CITY OF ALBUQUERQUE

**RE: 1600 First Street Northwest, Loading Dock Remodel
Revised Grading and Drainage Plan
Engineer's Stamp Date 2-5-16 (File: J14D178)**

GRADING AND DRAINAGE PLAN

date
12-15-15
sheet
C101

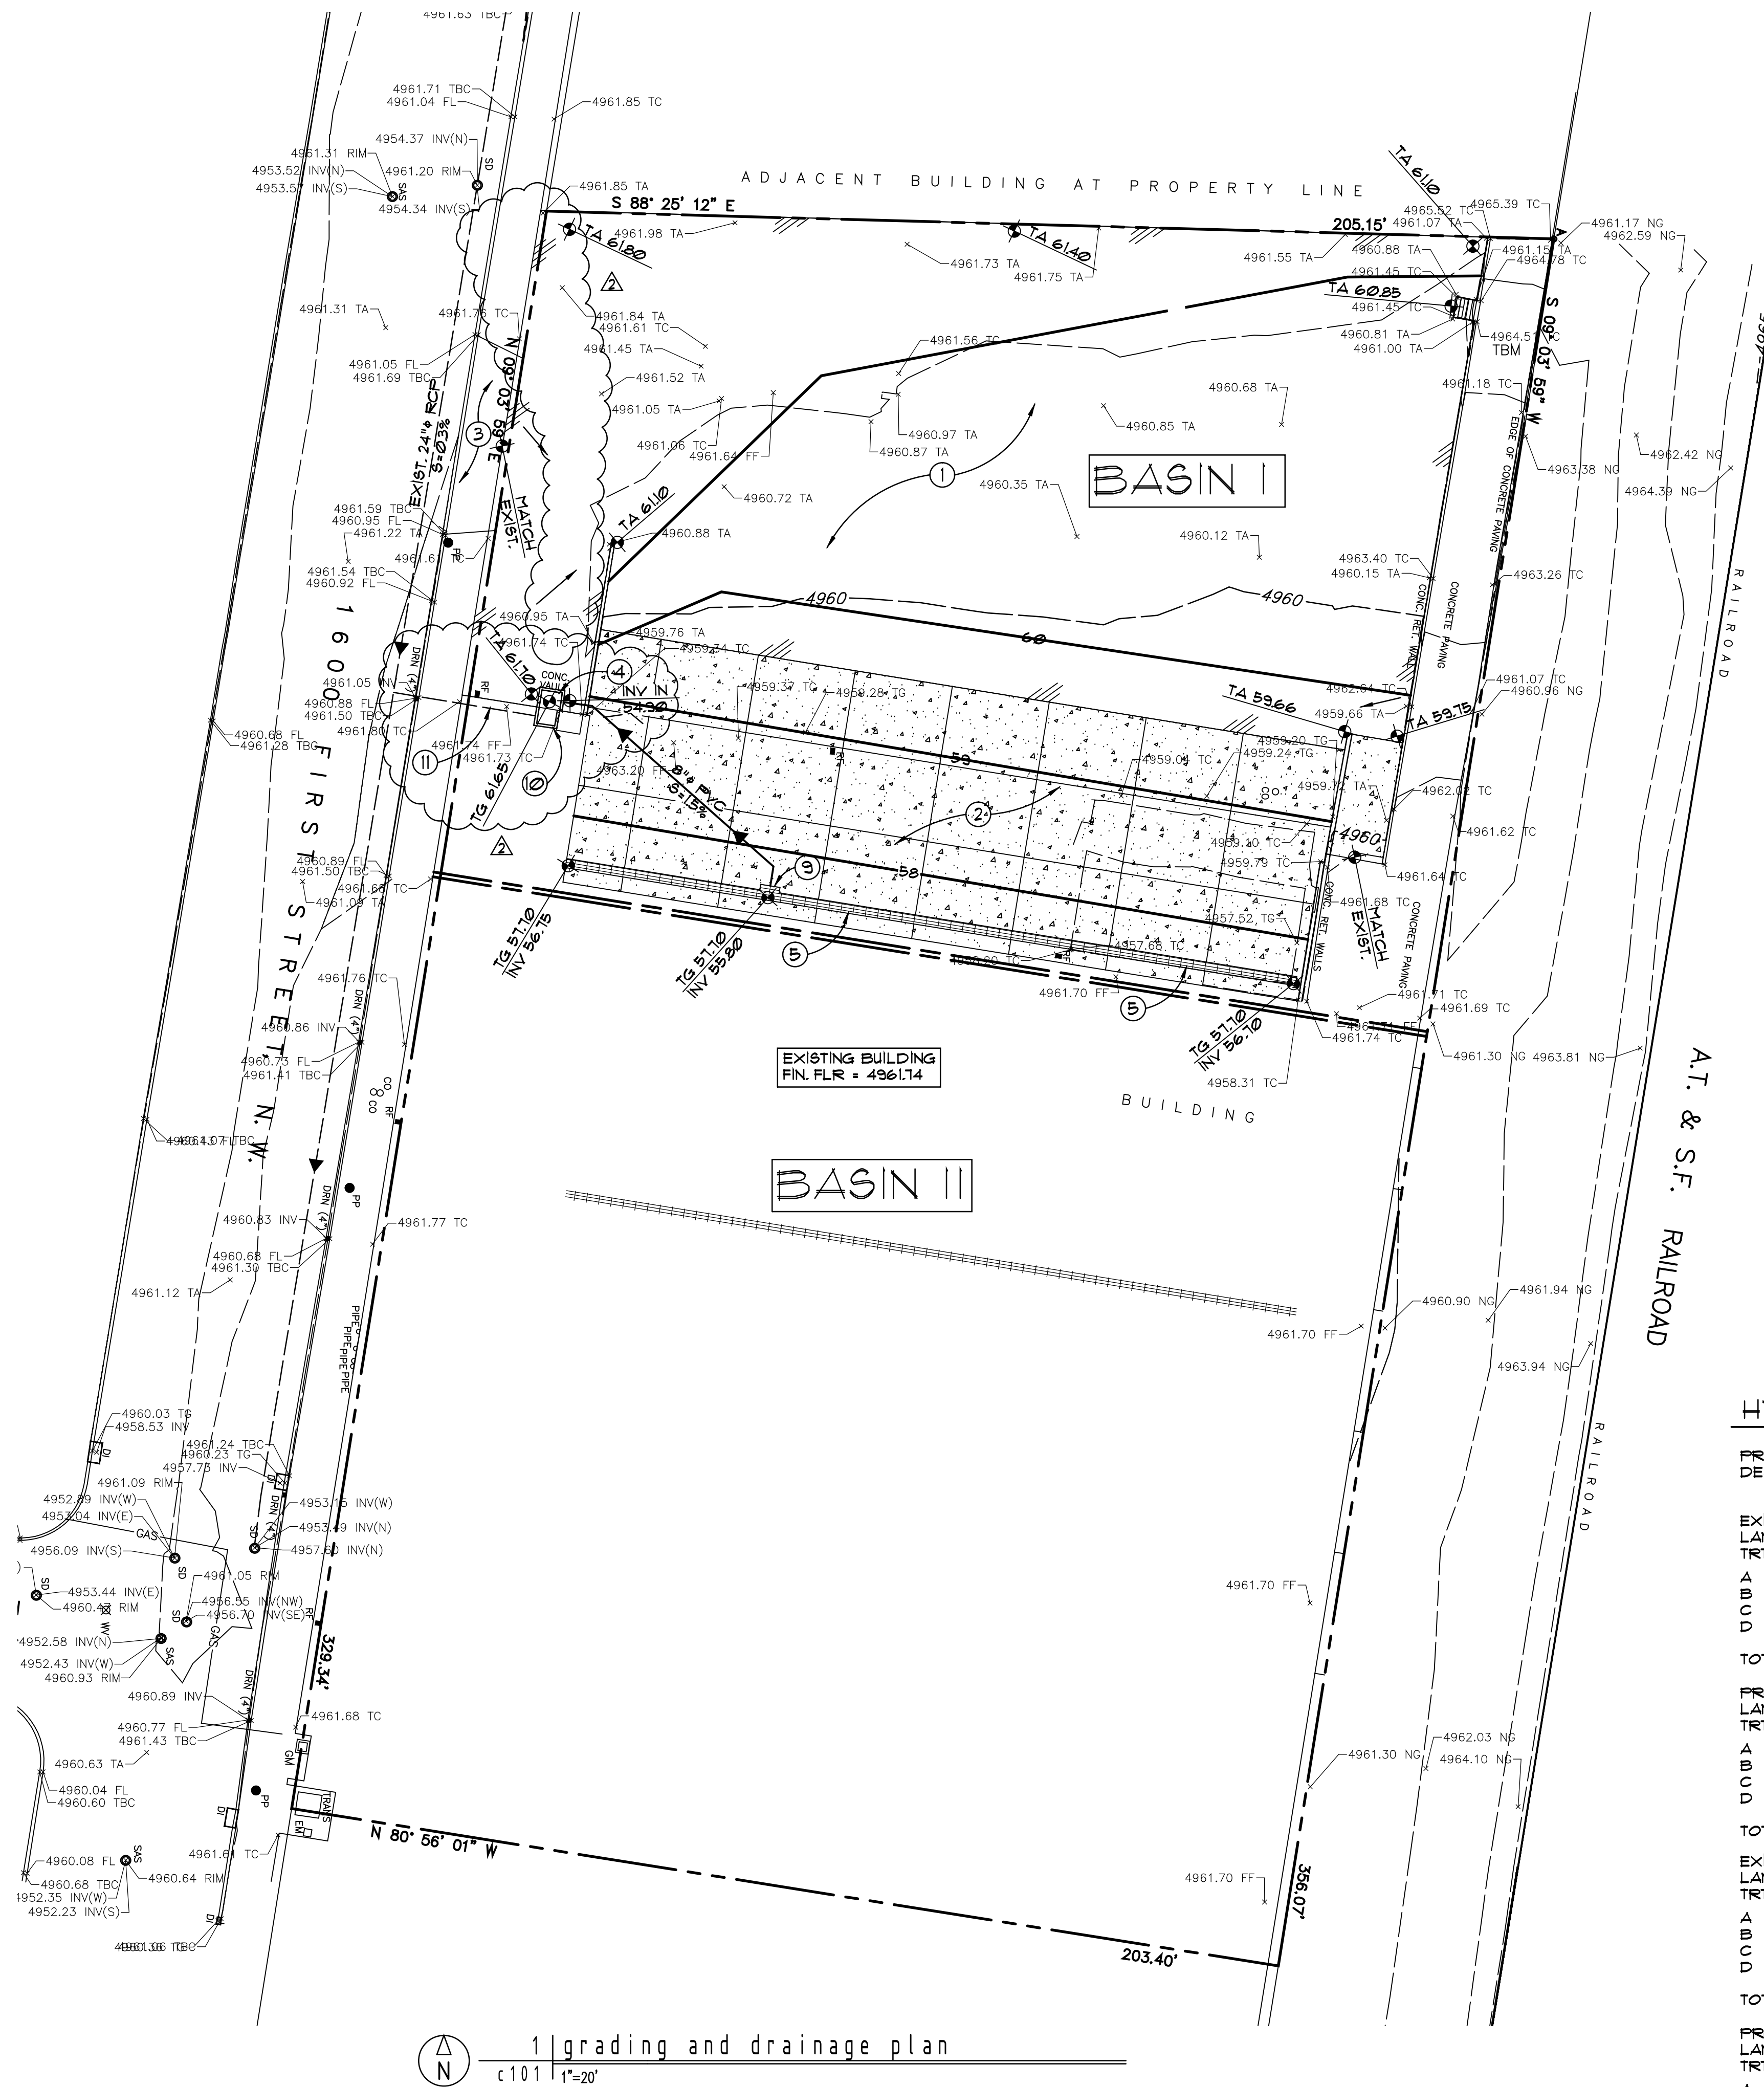
Based upon the information provided in your submittal received 2-5-16, the above-referenced revised plan is approved for Building Permit (SO-19 is no longer needed in this revised plan).

Please attach a copy of this approved plan in the construction sets when submitting for the building permit. Prior to Certificate of Occupancy release, Engineer Certification per the DPM checklist will be required. Please ensure that the existing piping under the sidewalk is completely cleaned.
